# Hawley Wharf

## Masterplan - Buildings A, C, WX & The Viaduct Arches

### Non-material Amendments - R022

2 November 2016

drawing title / location  
Building A Elevations

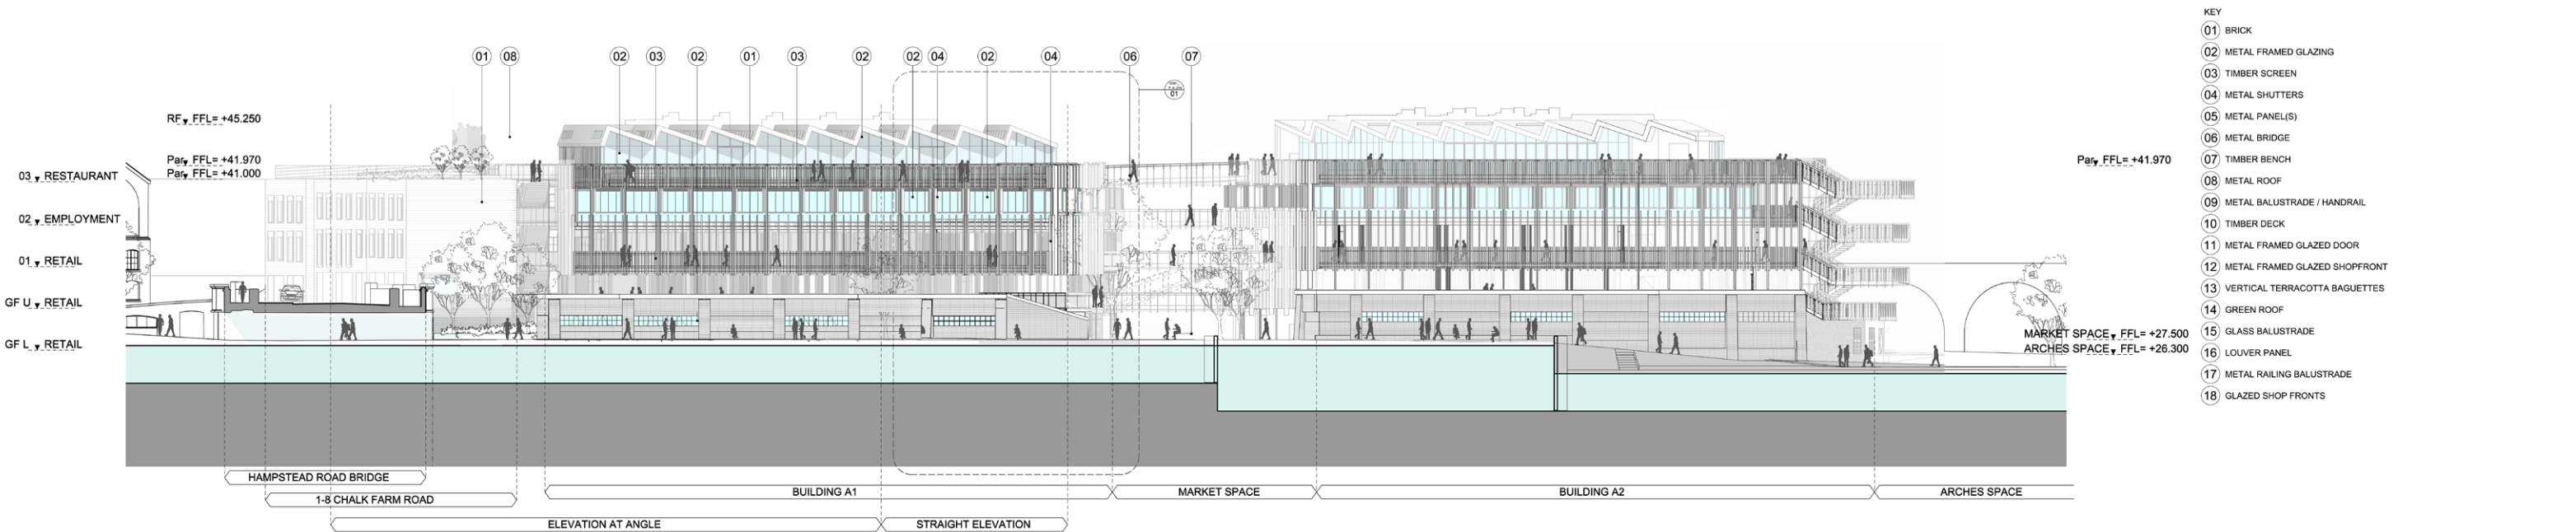
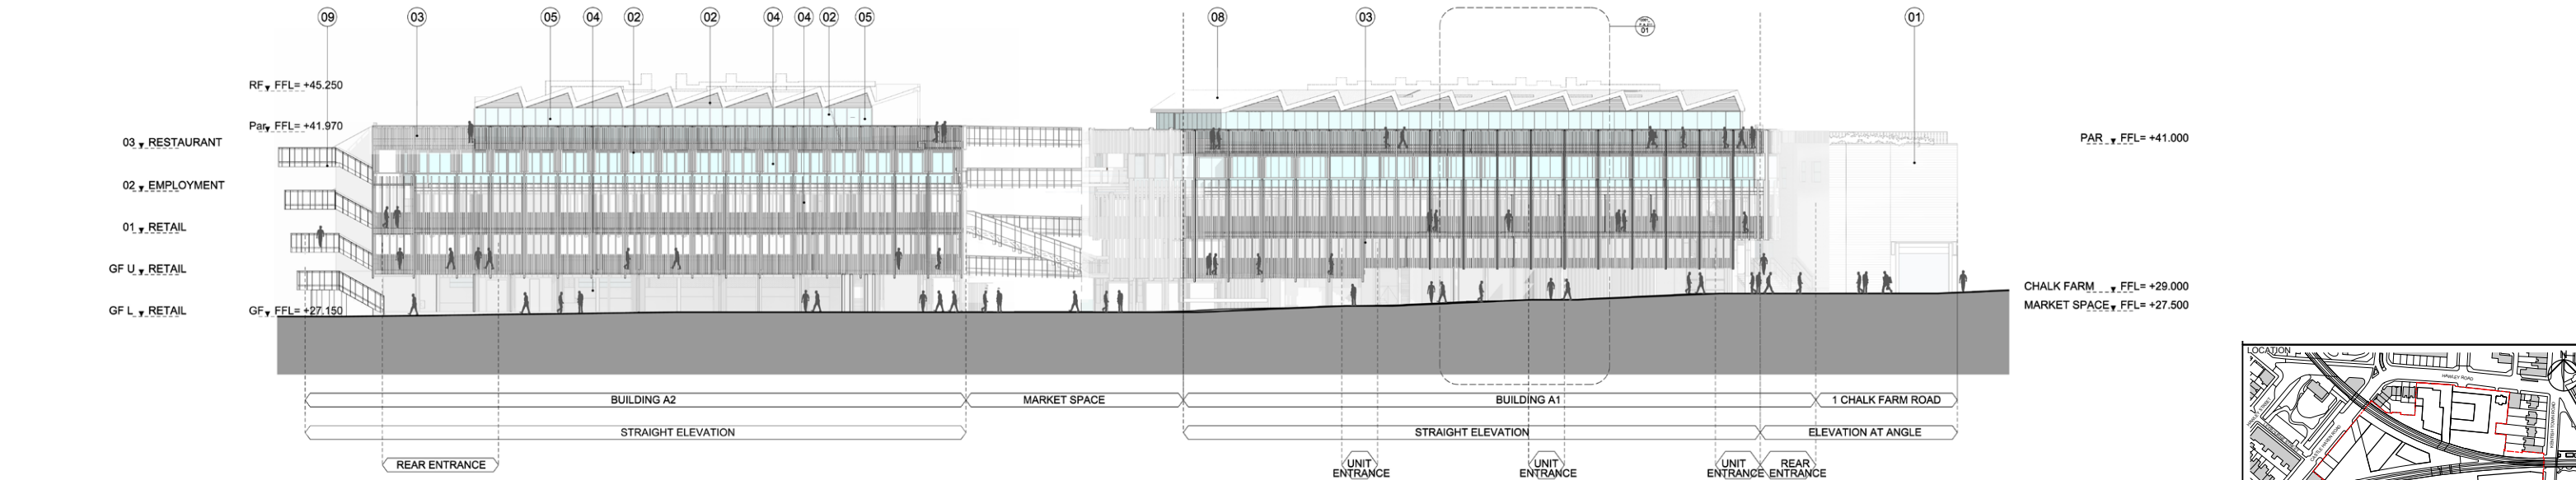
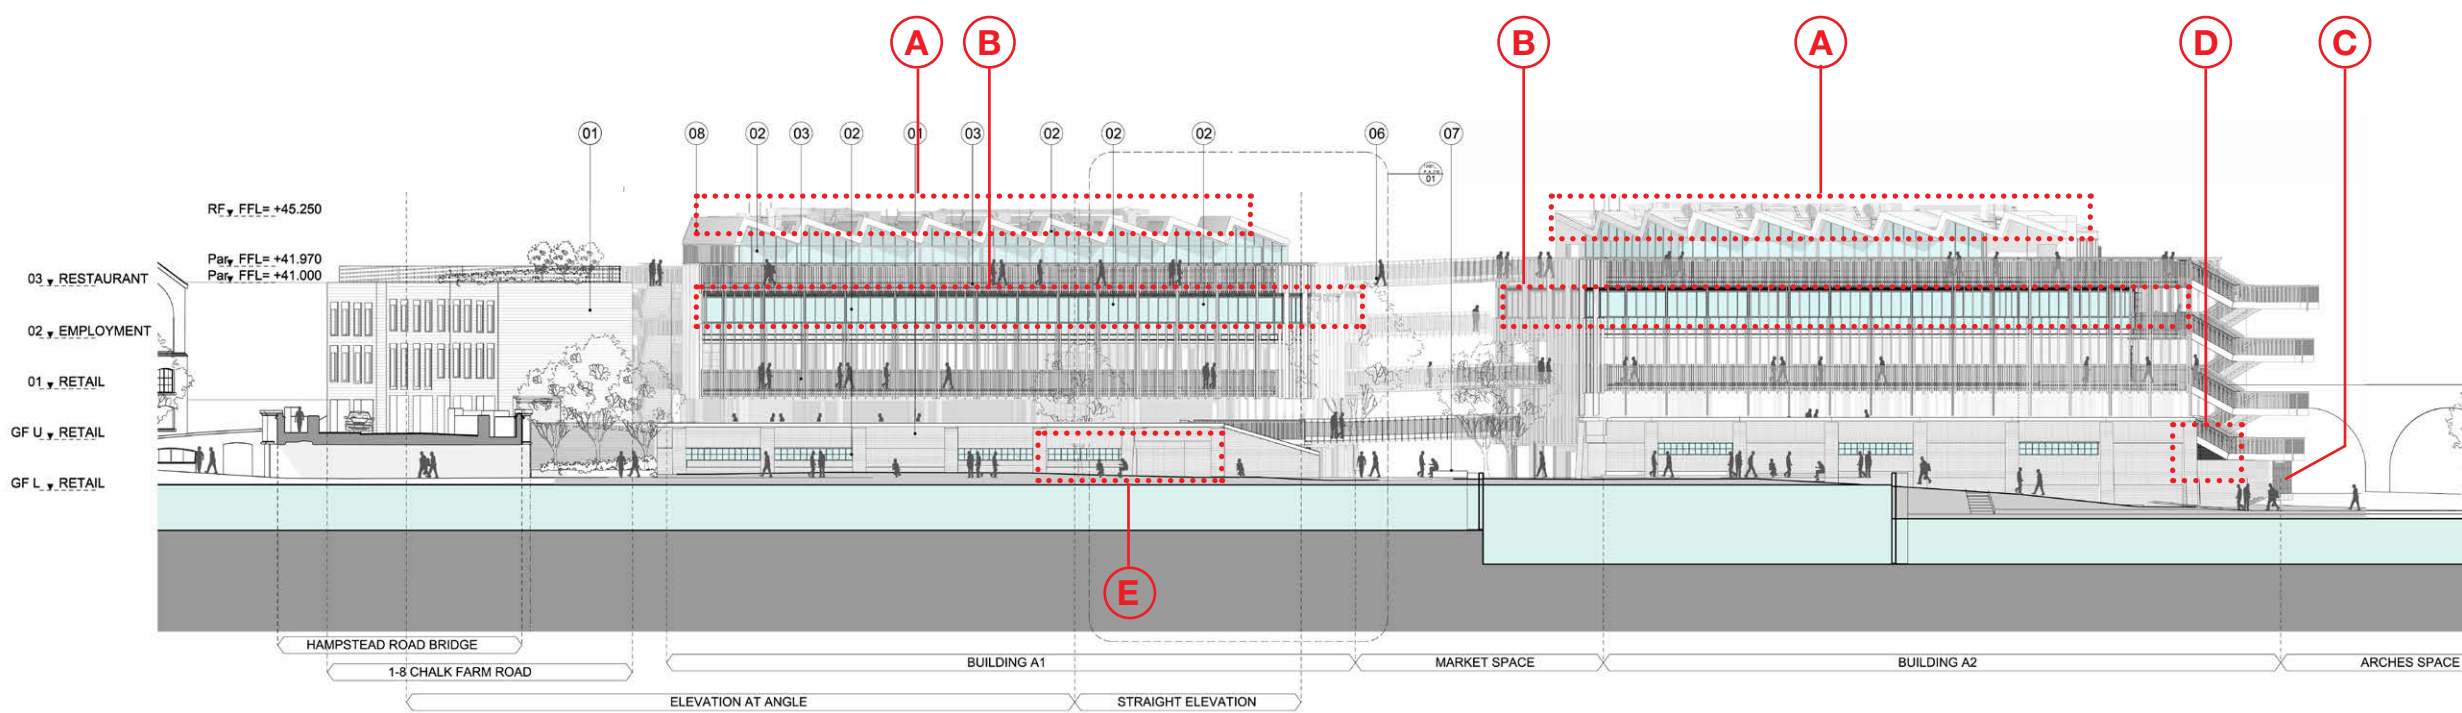
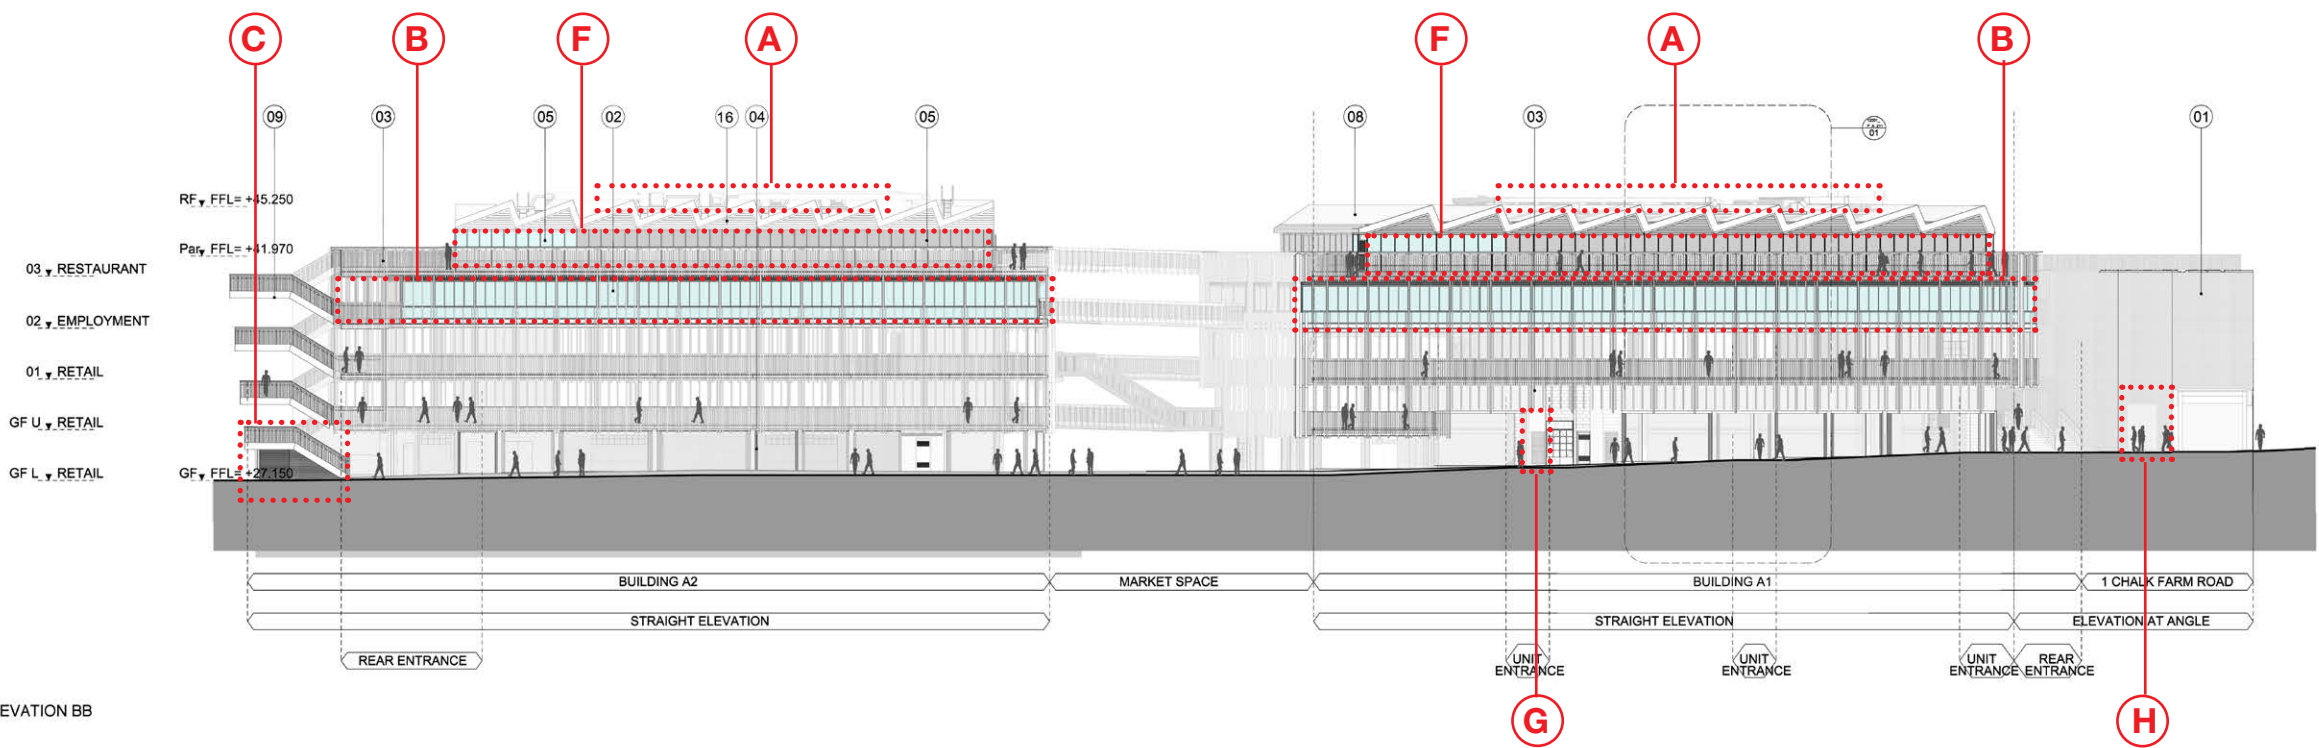
- A Rooftop Plant no longer requires chimneys
- B Omission of external shutters on second floor - refer to 2.13-2.23.
- C UKPN room enclosure to be louvred on east and north elevations
- D UKPN room requires louvres on south elevation
- E Canal Wall Window included in previous NMA relocated
- F Solidity of north facade increased on third floor restaurants, where plant and kitchens are expected to be located.
- G Ventilation shaft relocated adjacent to core 02
- H Additional fixed window (shown as door in previous NMA)
